City of Biddeford
Staff Review Committee
August 10, 2022 1:00 PM City Hall Conference Room (Second Floor) & Zoom
<https://biddeford.zoom.us/j/93029473020?pwd=bXRWdXArWlIRaTVUbFUvdKxZcGtiQT09>
ID # 930 2947 3020 Code: 152485

- 1.1. 2022.10 Review a Site Plan application for Donald Jackson to construct a 6,120 square foot building along with 6,981 square feet of pavement for access and parking. The address of the property is 7 Digital Drive (Tax Map 15, Lot 7-9) in the Industrial 1 Zone.

RE: 2022.10 Site Plan Review for Don Jackson at 7 Digital Drive (Tax Map 15, Lot 7-9) to construct a 6,120 SF building for office, light manufacturing, warehouse and storage uses in the Industrial-1 (I-1) zone.

DRAWN: P.P.G.	REVISIONS:	
CHECKED: P.P.G.		
SCALE: 1"= 30'		
FIELD BOOK:		
DATE: 05-17-2022		
JOB NO. 1817		
SHEET 2 OF 5	1. 07-08-22	RESPONSE TO 'SITE DESIGN' MEMO 06-16-22

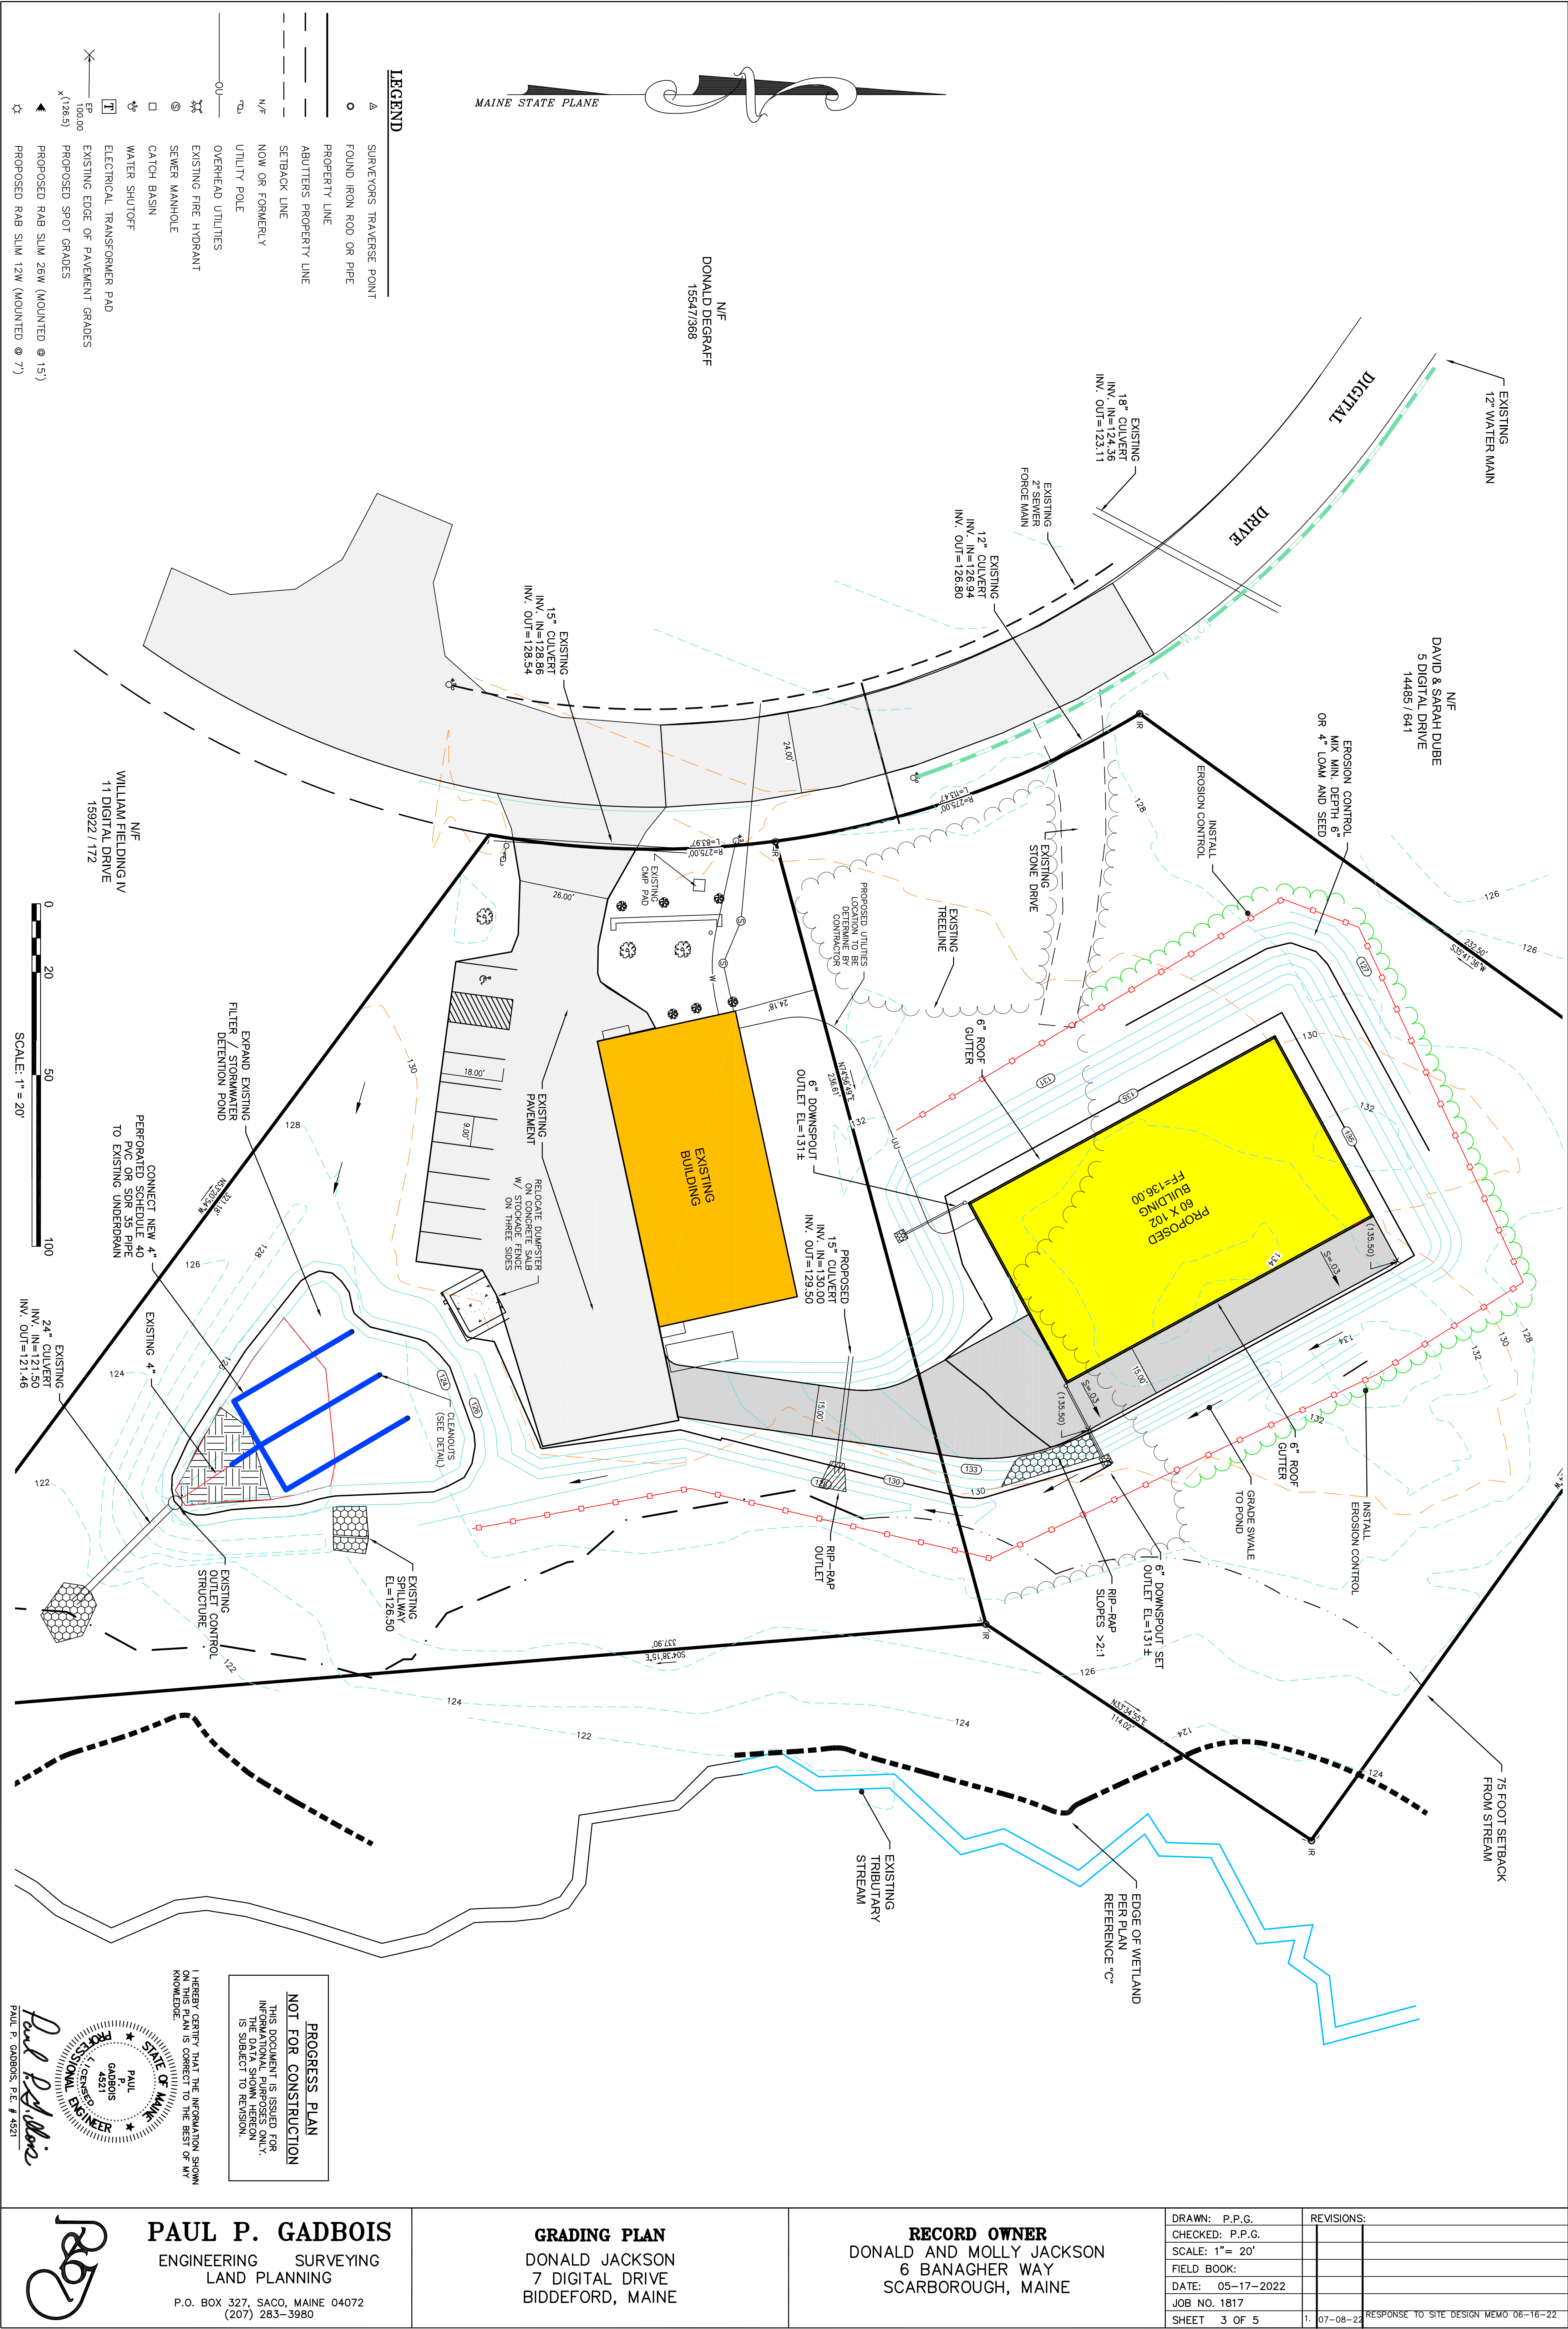
- a) Added spot grades as requested and lowered proposed slab elevation to Elevation 136.00. The pavement will slope 3% away from the building.
- b) Added inverts and erosion protection.
- c) The existing underdrain was revised to be shown in red.
- d) Added cleanouts on grading plan and to cross section on details.
- e) Elevations shown on detail sheet.
- f) Revised tree line.
- g) All slopes greater than 2:1 shall be riprap. All other slopes including slopes within the detention pond shall be loam and seeded or erosion control mix.
